Recall Bulletin 140609ARG

**RECALL
BULLETIN:
140609ARG**

2013 American Eagle,
American Revolution,
American Tradition
and
2014 American
Eagle and American
Revolution
manufactured
between
October 16, 2012 and
May 6, 2013

SUBJECT:
Inspection/
correction of seat
belt mounting
hardware

Figure 1
Left side of driver's seat shown.
Right side passenger seat the same.

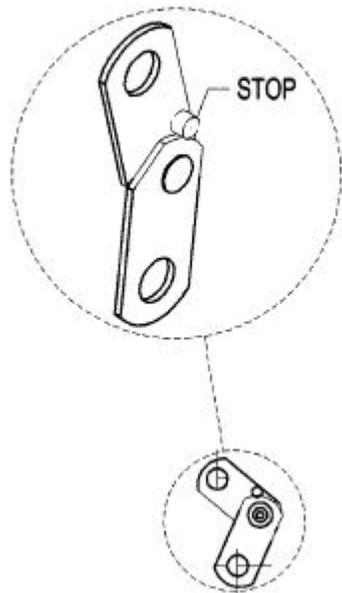
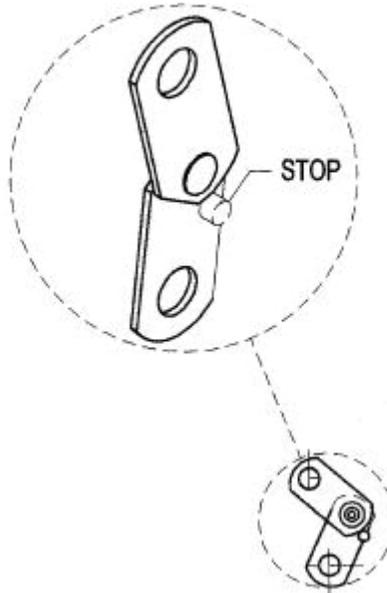
INSPECTION OF THE ABTS HINGE LINK

CORRECT INSTALLATION OF THE ABTS HINGE LINK

The ABTS hinge link is installed correctly when the upper link with the stop is toward the seat frame and the lower link is outboard from the seat frame.

INCORRECT INSTALLATION OF THE ABTS HINGE LINK

The ABTS hinge link is installed incorrectly when the upper link is outboard from the seat frame and the lower link with the stop is inboard from the seat frame.

Figure 2

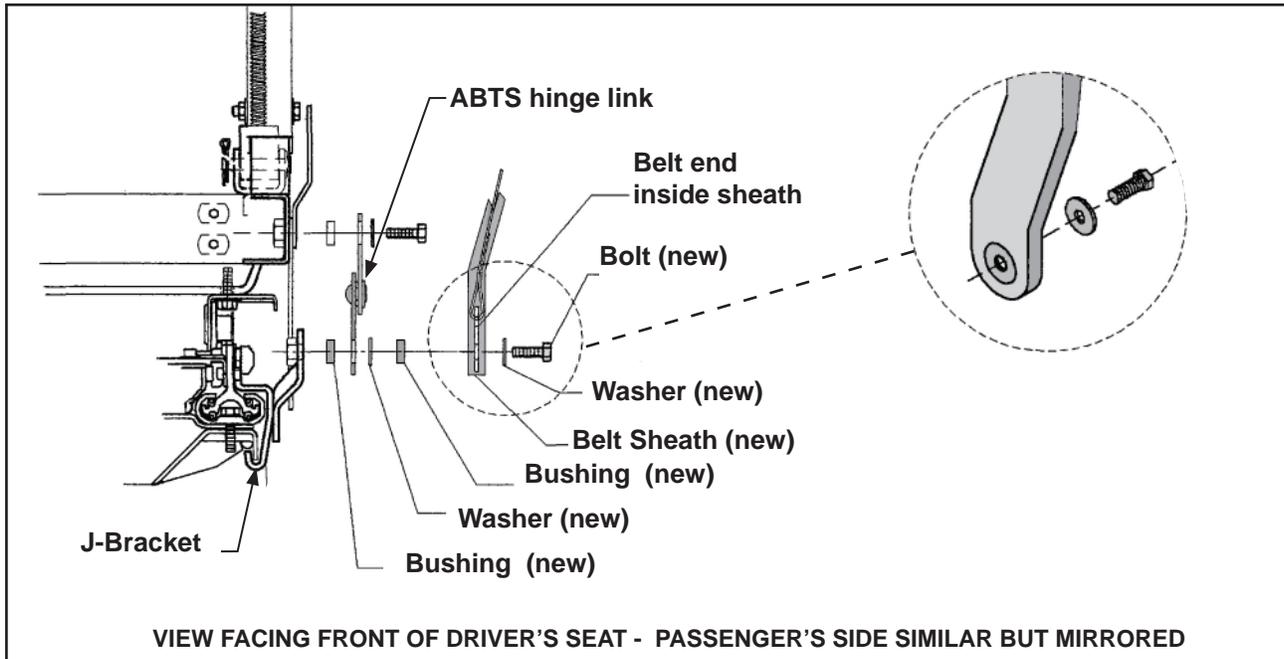
Motor homes affected by this recall may be equipped with certain Villa International brand powered driver and passenger seats, with improperly installed seat belt bracket attachment assemblies. Improperly installed attachment hardware could damage and weaken the seat belt over a period of time, potentially resulting in a seat belt failure.

1. Remove the hardware fastening the seat belt to the seat base assembly. Discard the original bolt, bushing, and washers.
 Note: The new bolt supplied with the repair kit is longer than the original bolt; this will enable full thread engagement into the J-bracket nut.
2. Ensure the seat belt is free of twists, then slide the belt sheath (included with the recall kit) onto the seat belt as shown in Figures 2 and 3.

3. Referring to the installation diagram in Figure 2 and the photos (Figures 3 & 4), reinstall the seat belt to the seat base using the new hardware included in the recall kit. Ensure the assembly order is correct. Torque the attachment bolt to 20 ft-lbs.

NOTE: Hand-start the bolt to avoid cross-threading.
